OSSF Inspection Sheet

Permit of Authorization to Construct an On-Site Sewage Facility Permit Valid For One Year From Date Issued

Permit Number: 118612
Issued This Date: 06/11/2025
This permit is hereby given to: Adolfo G. Garcia

On-Site Sewage Facility Application and Design

DATE: 9/24/2025

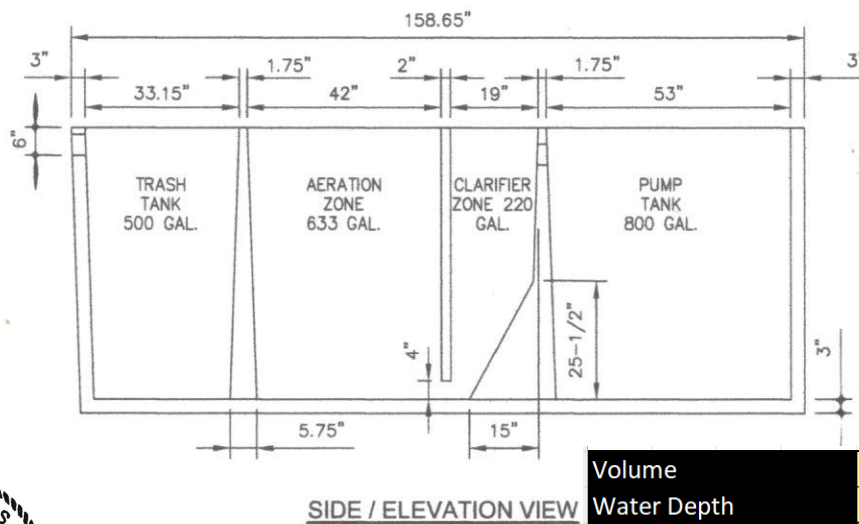
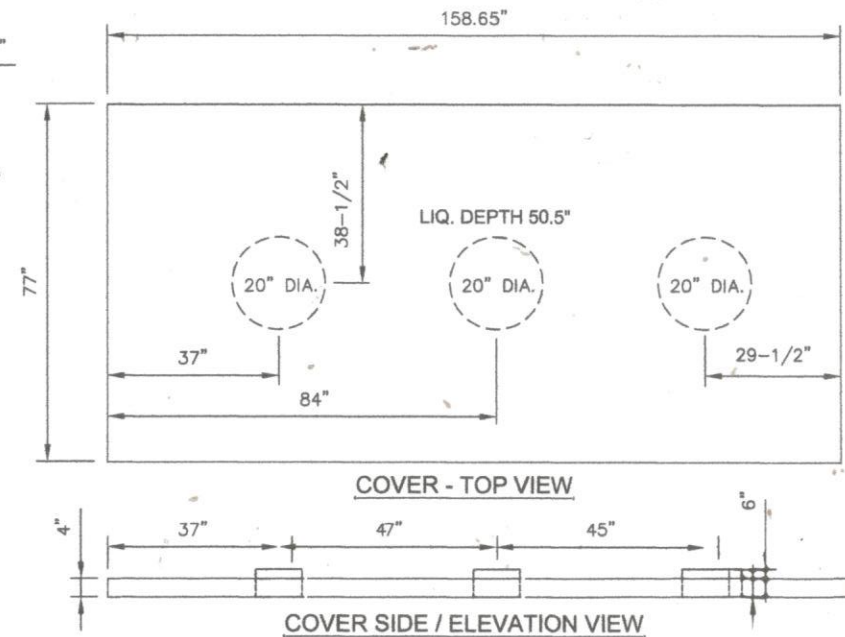
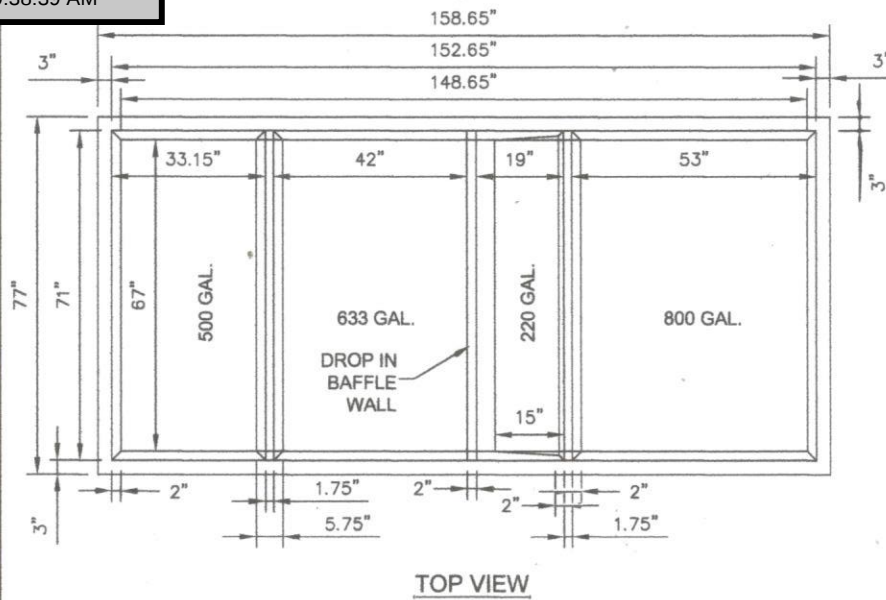
Thank you for your submission. We have reviewed the planning materials for the referenced permit application, and unfortunately, they are insufficient. To proceed with processing this permit, we require the following:

- ✓. 285.91(10) Table X
- ✓. There is a 20 ft separation distance from edge of spray to property lines.
- 2. Revise accordingly and resubmit.

The unique circumstances of this property make it difficult to comply with the 20ft spray setback requirement. I hereby request a variance for the placement of the spray disposal area 10 feet from the property lines, as well as a battery backup timer to be installed to ensure sprayers only spray during the predawn hours. Installing this timer will provide equivalent protection with TCEQ CHAPTER 285 rules Table X. In my professional opinion this variance will not pose a threat to the environment or public health.
